Carolina Power & Light Company

OG-137  
Ref: OG-110,  
12/1/83 &  
OG-117  
3/9/84  
October 25, 1984

Westinghouse Owners Group  
Program to Address Generic Letter 83-10 - RCP Trip  
Response to NRC Questions

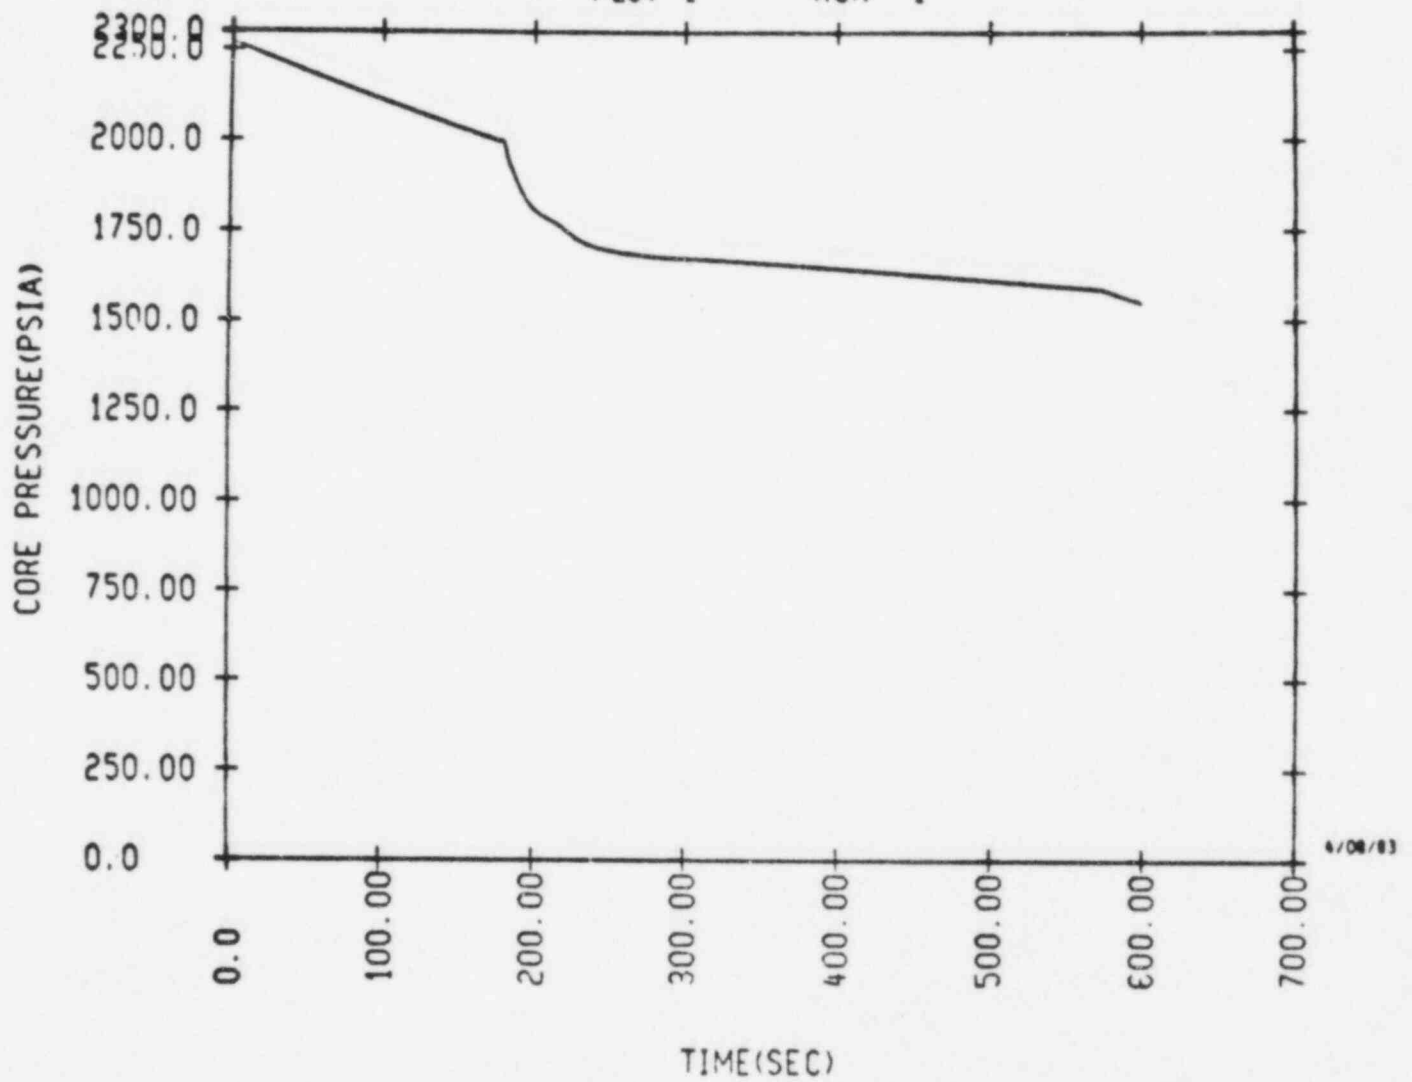
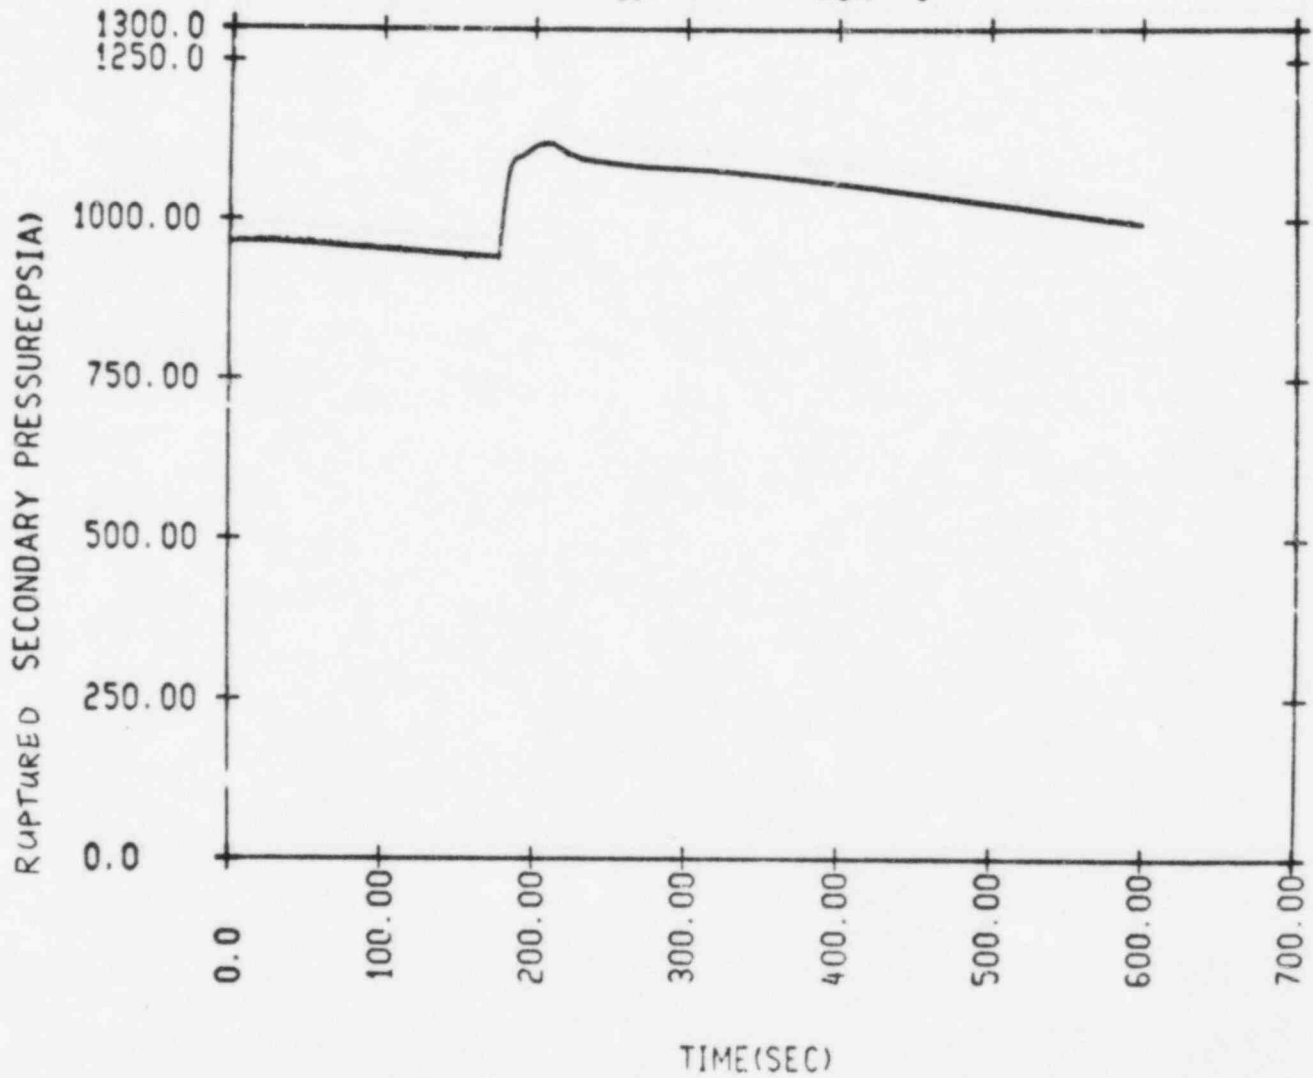
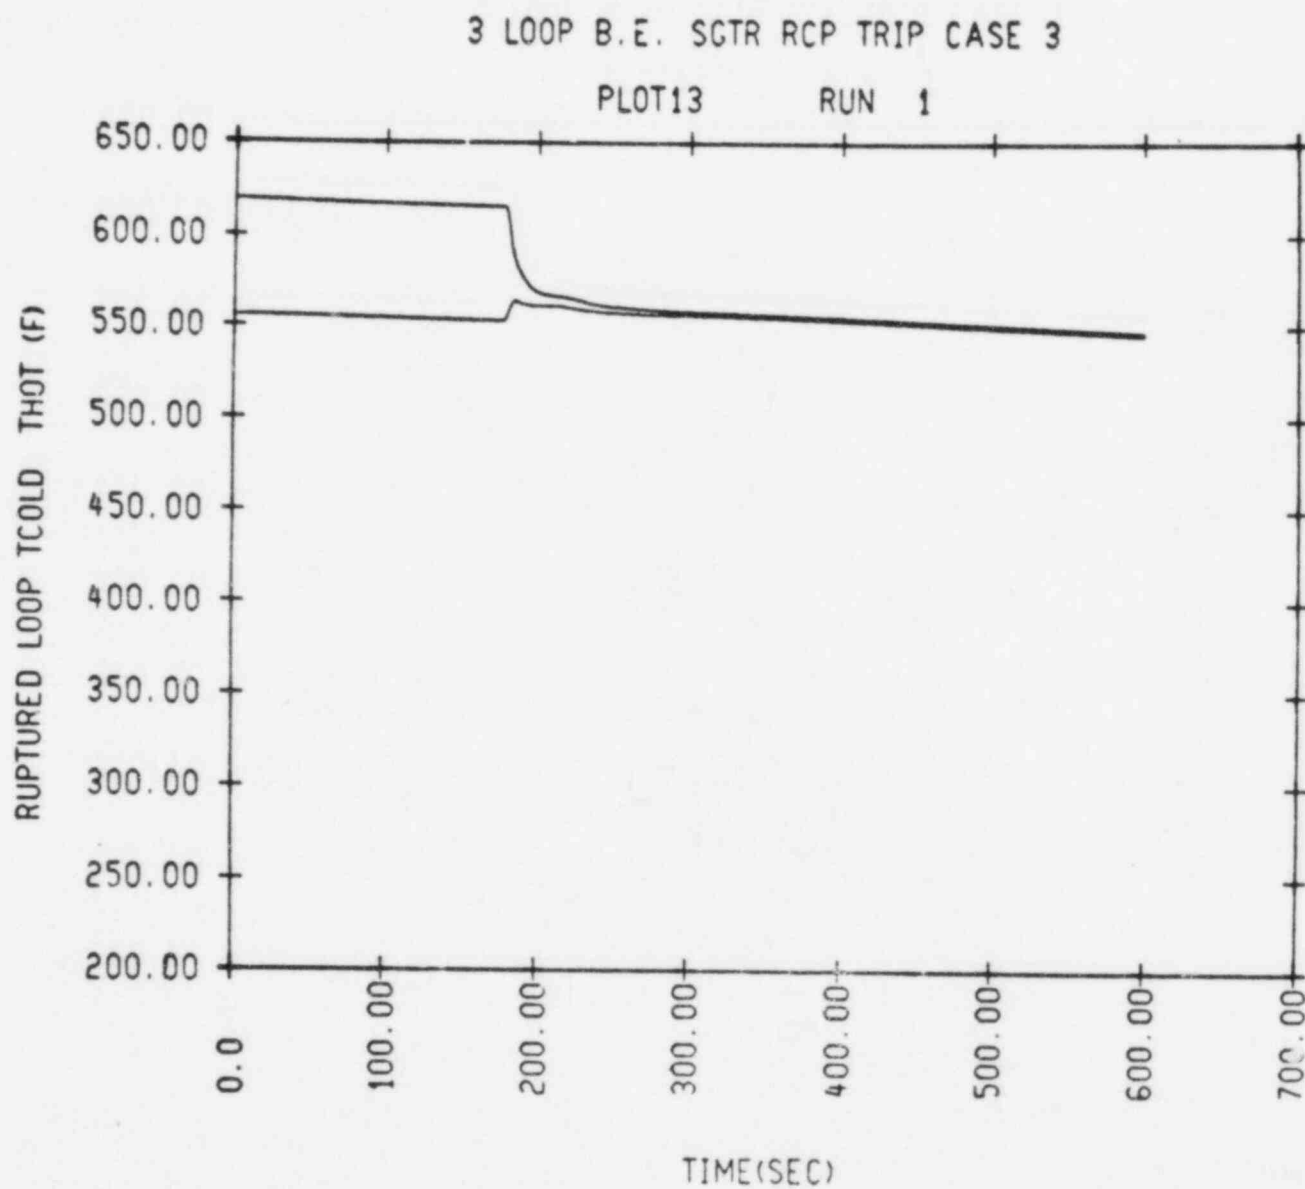
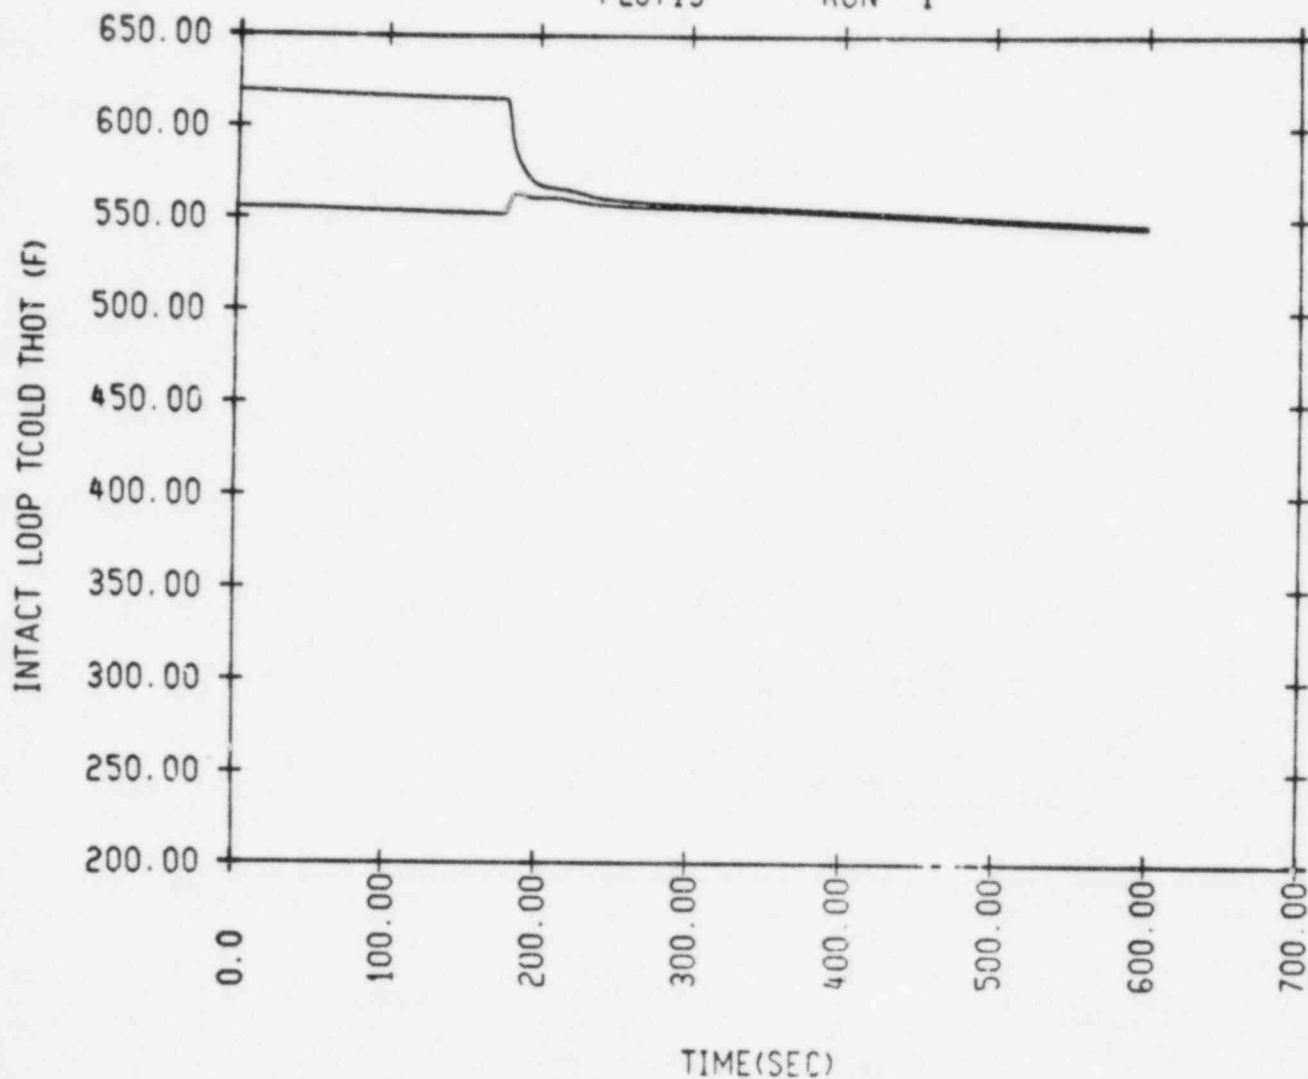
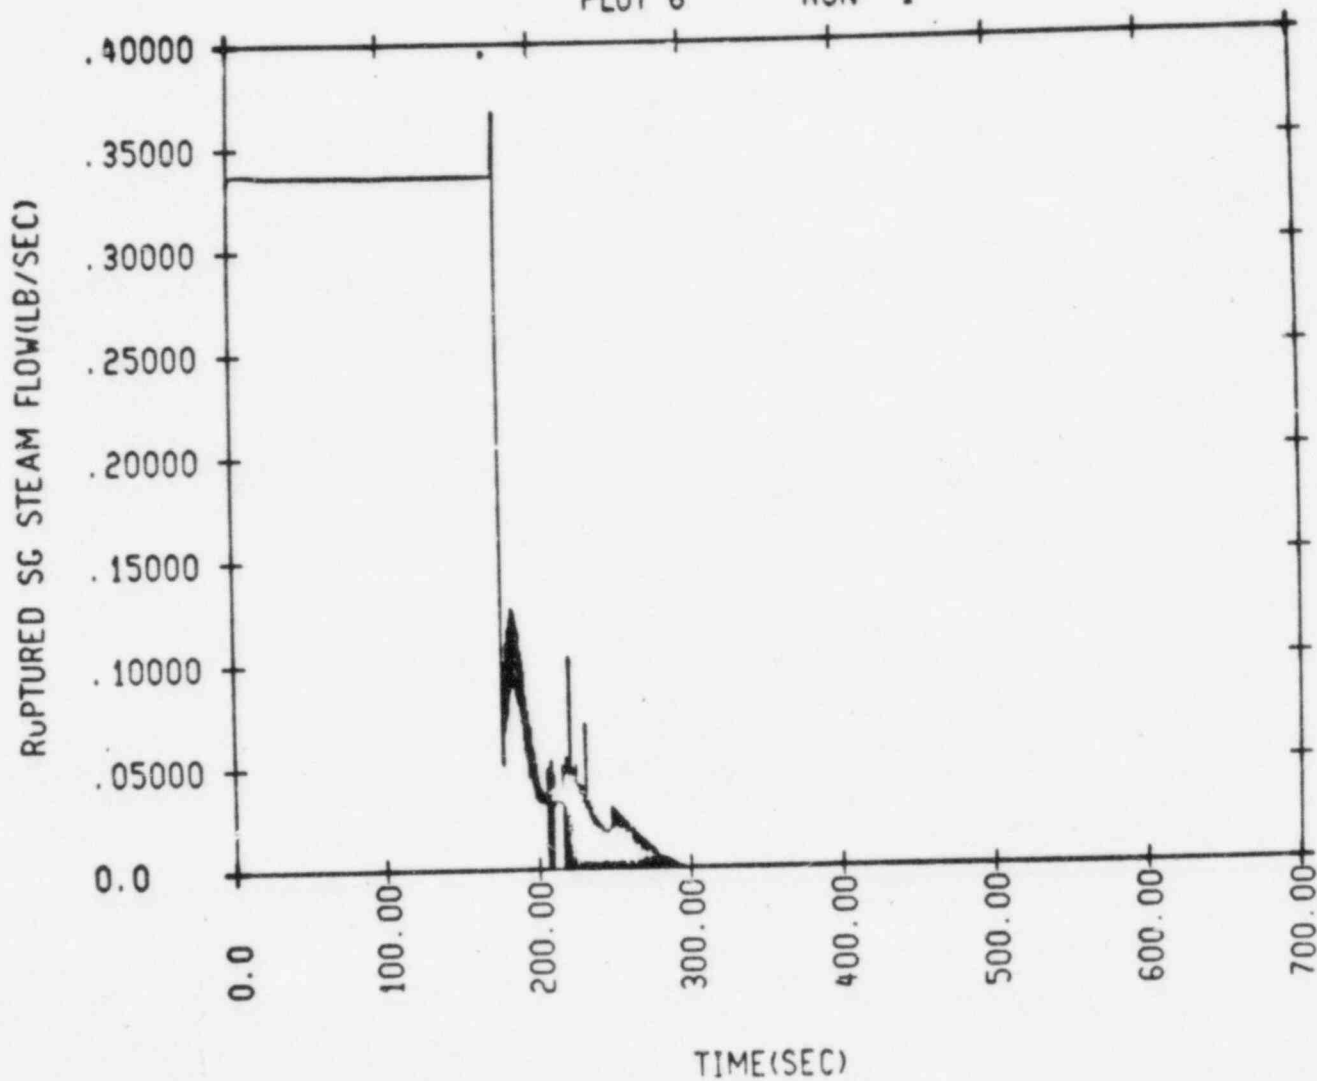
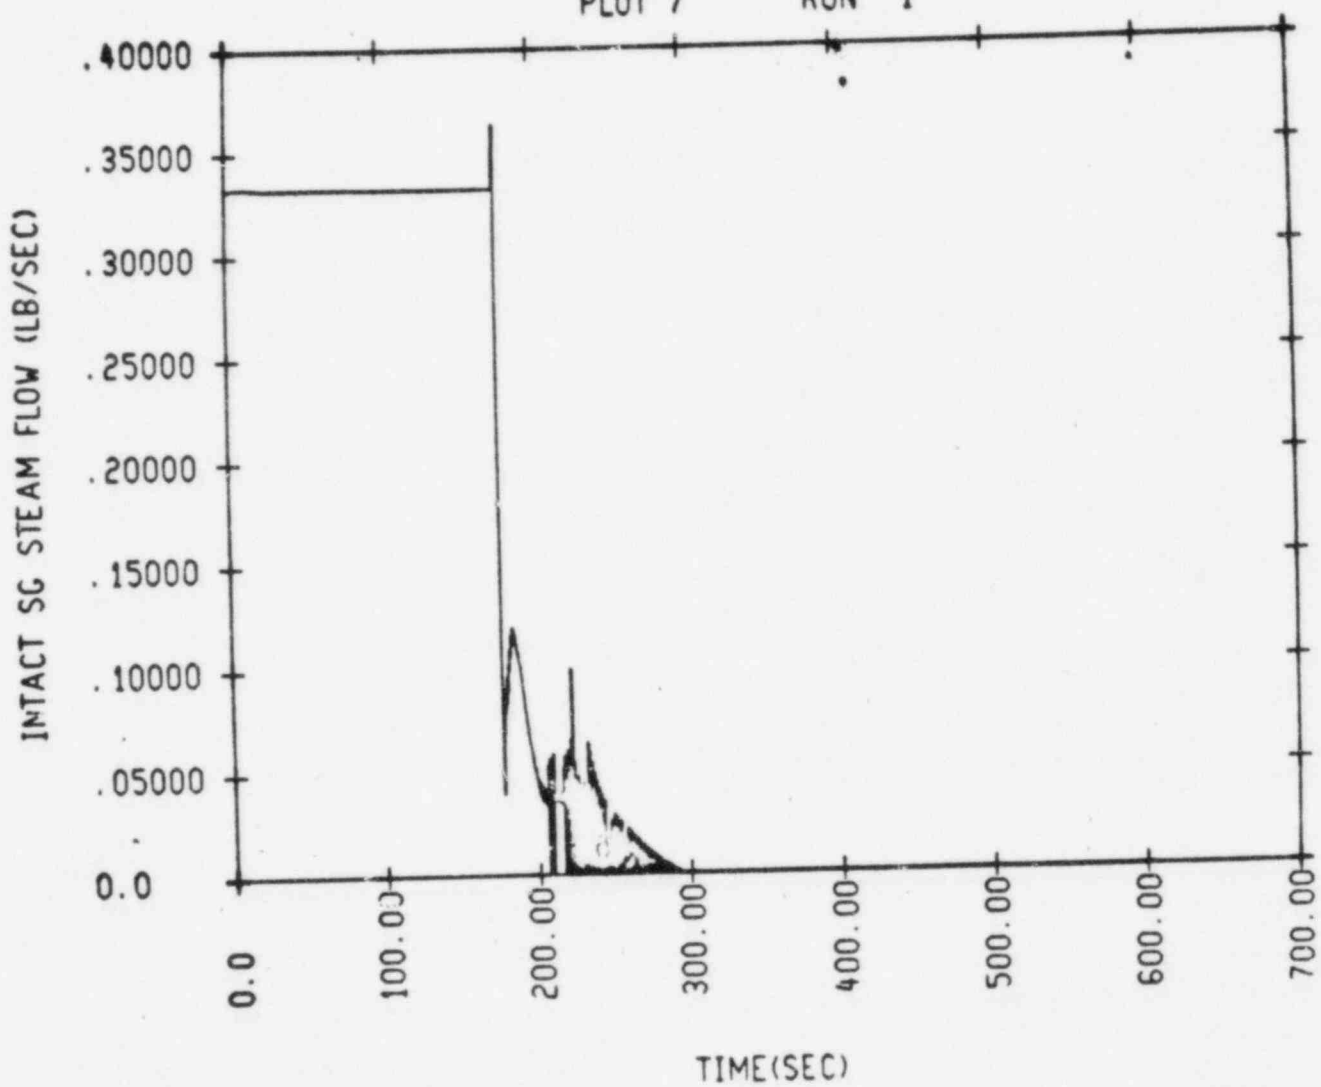
Q.73 We will be performing independent, confirmatory analyses of selected SBLOCAs and SGRs. In order to benchmark our calculations, please provide plots of the following parameters for the 3-loop generic PWR, for the 3.3 inch diameter SBLOCA and for the design base SGTR (where noted (\*)) these data were presented in the submittals for the SBLOCA case, .

- 1) RCS pressure - Figure 1
- 2) Secondary side pressure, ruptured - Figure 2  
Secondary side pressure, intact - Figure 21
- 3) Hot leg and cold leg temperatures, ruptured - Figure 3  
Hot leg and cold leg temperatures, intact - Figure 4
- 4) Core mixture level - Not applicable
- 5) SGTR rupture mass flow rate - Figure 3L Case 3 of Ref. 3
- 6) Integrated SGTR rupture mass flow rate - Figure 20
- 7) Hot rod temperature - Not applicable
- 8) RCS loop mass flow rate, ruptured - Figure 19  
RCS loop mass flow rate, intact - Figure 19
- 9) Steam flow rate, ruptured - Figure 5  
Steam flow rate, intact - Figure 6  
Total feedwater flow rate, ruptured - Figure 18  
Total feedwater flow rate, intact - Figure 18
- (10) Total Safety injection mass flow rate - Figure 17

The following pages contain the requested information in the form of graphs where applicable. It should be noted that only one figure is provided for Hot Leg Fluid Temperature, Cold Leg Fluid Temperature and Steam Generator Pressure. This is due to the fact that the variances in temperature and pressure for the figures would be imperceivable between the broken and intact loops, therefore, only one figure was provided.
